Grandview Reserve FINAL DRAINAGE REPORT

HR Green Project No: 201662.03

PCD File No. CDR228

Grandview Reserve Final Channel 'B' Drainage Report

EXISTING FLOODPLAIN EXHIBIT

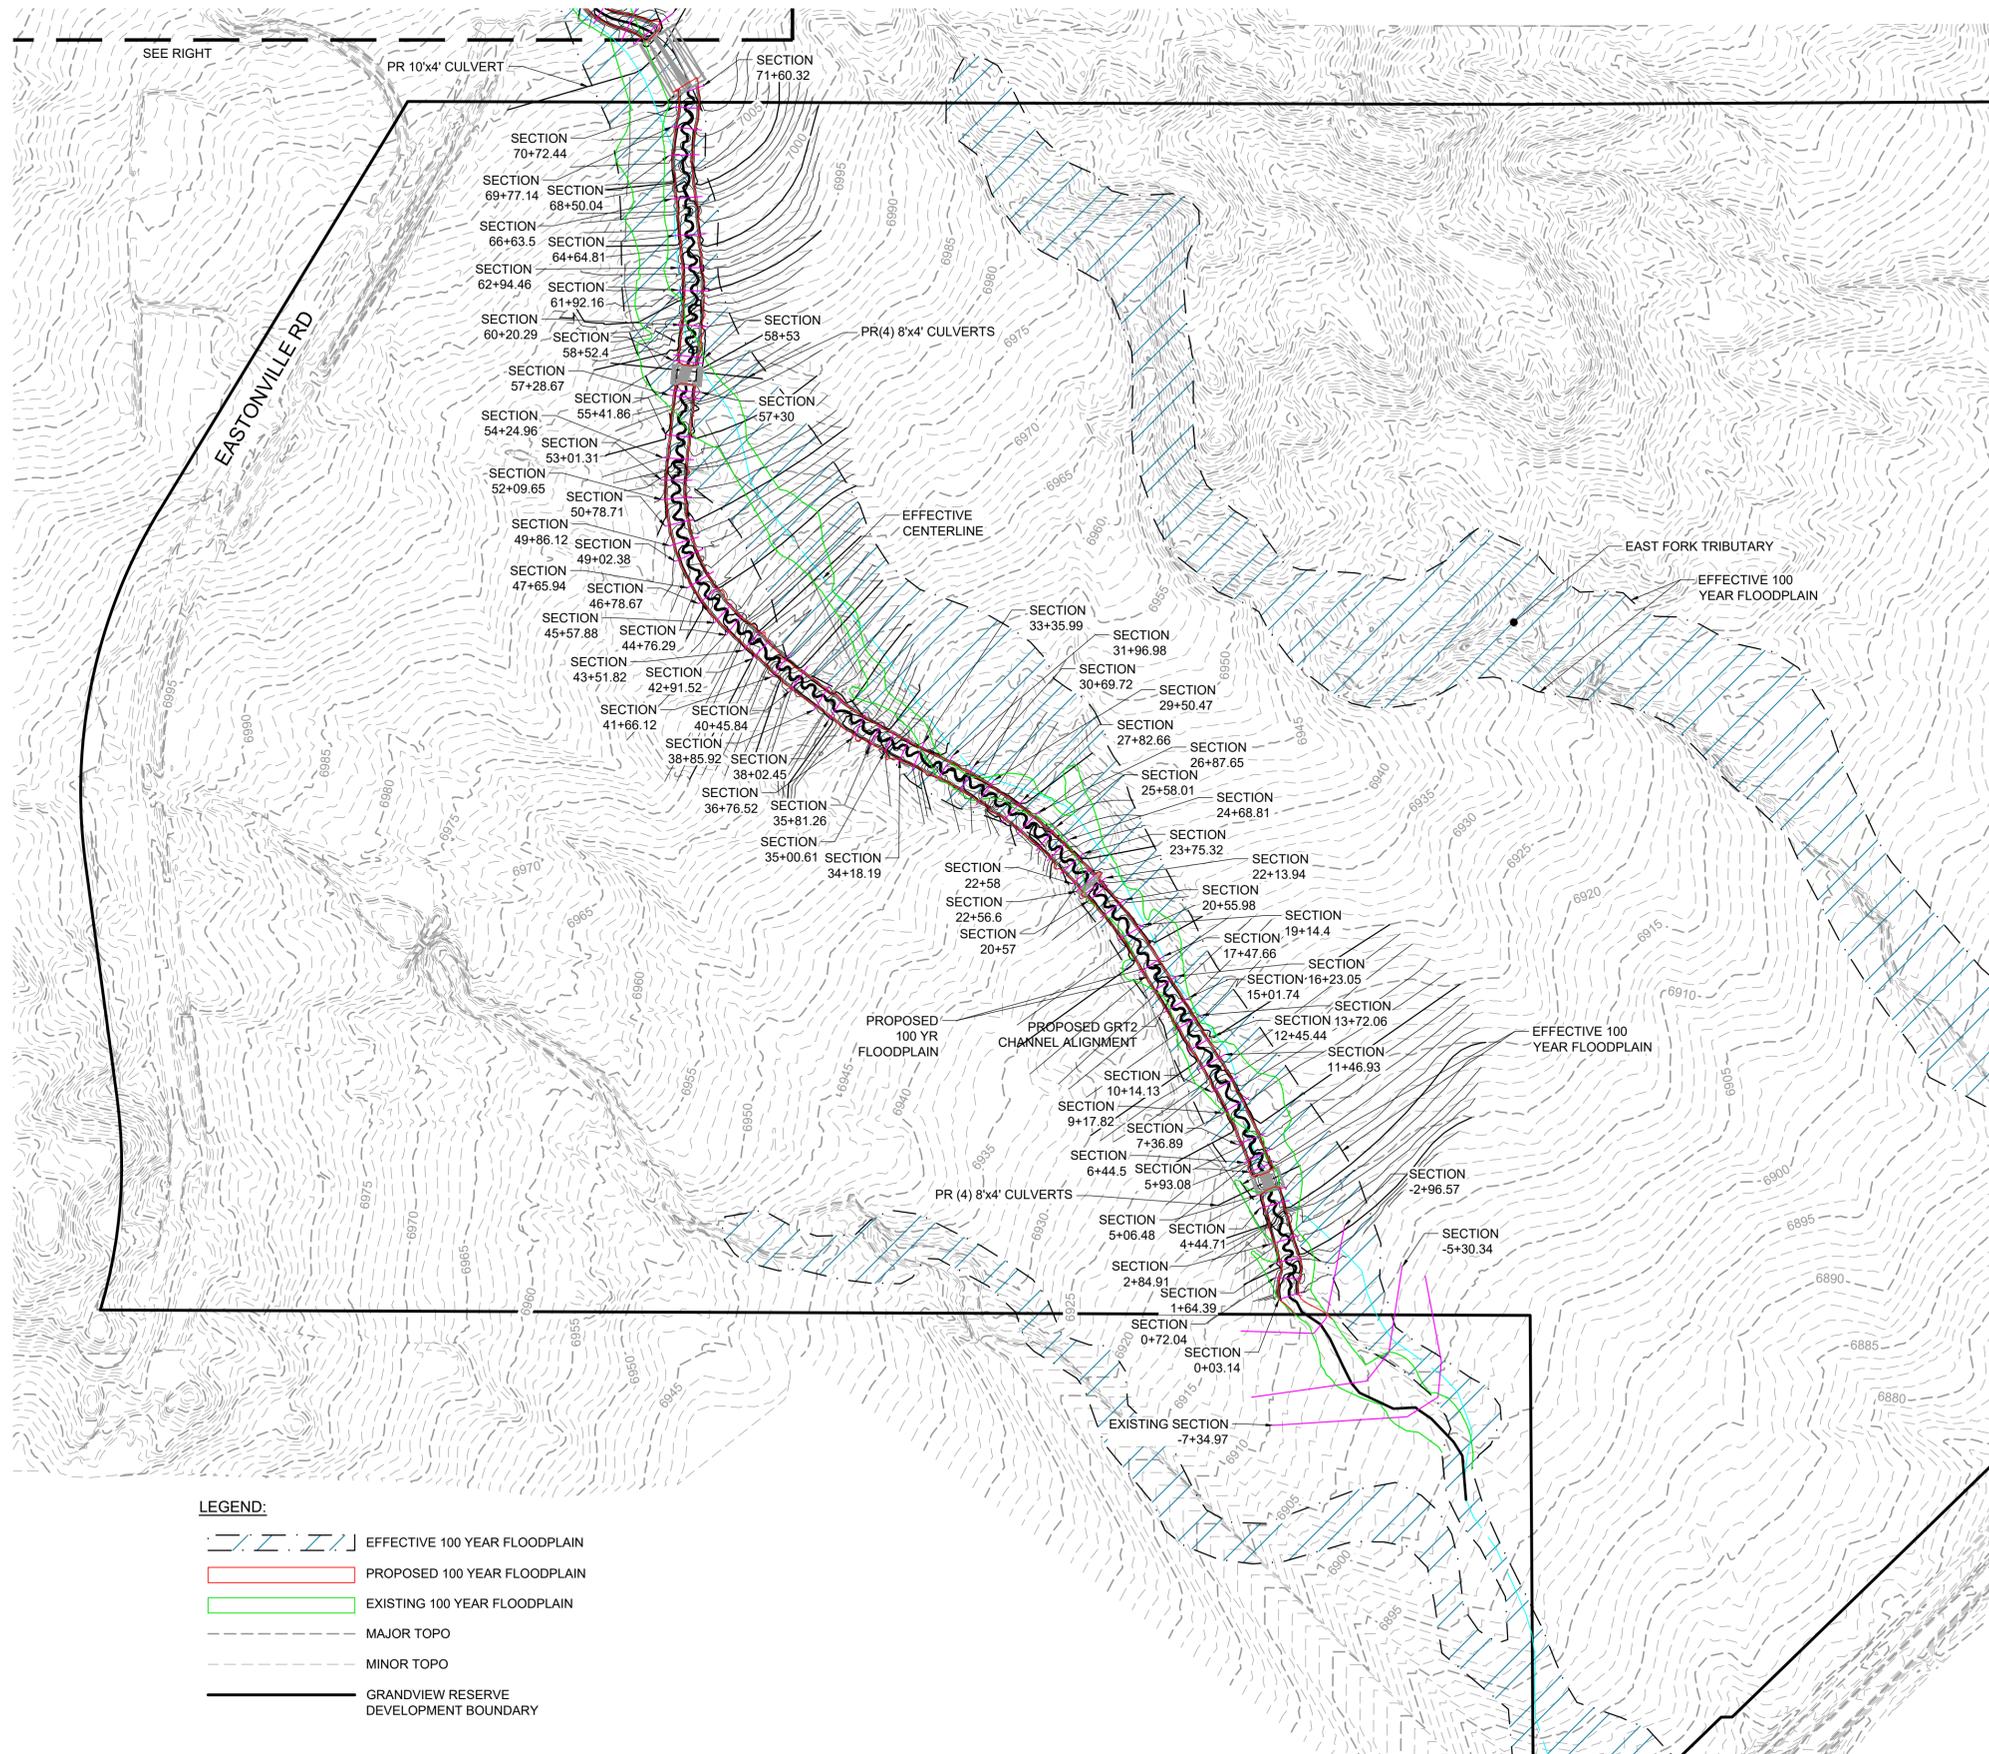
Provide profile &
output table
